ATTACHMENT A

City's letter to SAPCB and Director Paylor, "Proposed Stationary Source Permit to Operate Dated October 19, 2007, Mirant PRGS, Alexandria, Virginia", November 17, 2007

**Re: Proposed Stationary Source Permit to Operate Dated October 19, 2007
Mirant Potomac River Generating Station, Alexandria, Virginia**

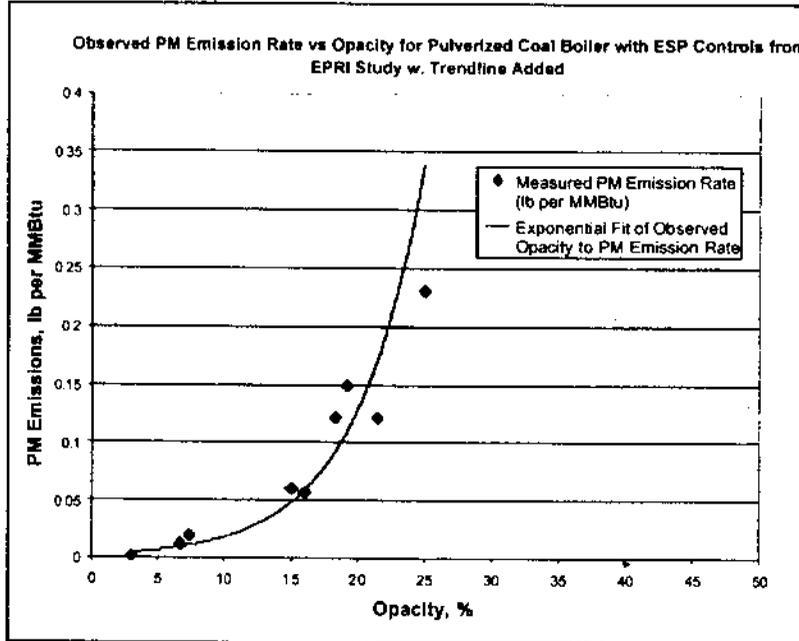
The figure below shows a curve fit between observed emission rates and opacity for testing of a pulverized coal boiler, obtained by Electric Power Research Interest Group, and reported by U.S. EPA.⁷ These data clearly show that opacity positively correlates with PM emissions. Of particular concern to Alexandria is the fact that opacity is closely related to fine particulate matter in the size range of about 1 µm. Therefore, any increase in opacity is very likely related to increases in PM_{2.5} emissions.

In response to Alexandria's recent request for data and analyses relating opacity increases to either increases or decreases in PM emissions, VDEQ wrote that it has "determined that the information that you have requested cannot be found or does not exist in the records of the Department of Environmental Quality" and that the VDEQ is "not aware of another source of the information you requested." VDEQ also wrote that the "Department is neither aware of nor in possession of the any documents, studies, or analyses relating the two or discussing the effect of increased opacity on emissions of total PM." Yet, VDEQ appears to agree with Mirant's claim that the December 2006 stack test demonstrated a reduction in PM emissions due to the use of trona. On the contrary, the December 2006 stack test is inadequate to make such a claim. First, the comparison of PM emissions with and without trona was only performed for one boiler that showed the smallest increase in opacity, i.e., Boiler 3. No other boiler was tested for this purpose. Second, the stack test reflects a one-time demonstration under controlled circumstances that are not representative of routine emissions. This is evidenced by the fact that Mirant has requested a PM emission limit of 0.055 lb/MMBtu, i.e., a limit that is two to five times higher than the actual stack test results. Additionally, and perhaps most importantly, the stack test results without trona use are based on a dismal performance of the cold-side ESP (CSEP3), i.e., an average PM control efficiency of only 53%. Such low control efficiency represents faulty performance of CSEP3 and resulted in higher PM emissions during the tests when trona was not in use. In contrast, the CSEP3 control efficiencies during the tests with trona ranged from 89% to 94%, which are more representative of the actual capability of CSEP3. Therefore, while the stack test with trona may reflect accurate emissions from Boiler 3, a comparison of these emissions with the results without trona is flawed and cannot be used to claim PM reduction due to trona use. Alexandria requests the Board and VDEQ to remove the reference to dry sorbent injection as a means to control PM emissions in Condition 5 of the proposed SOP.
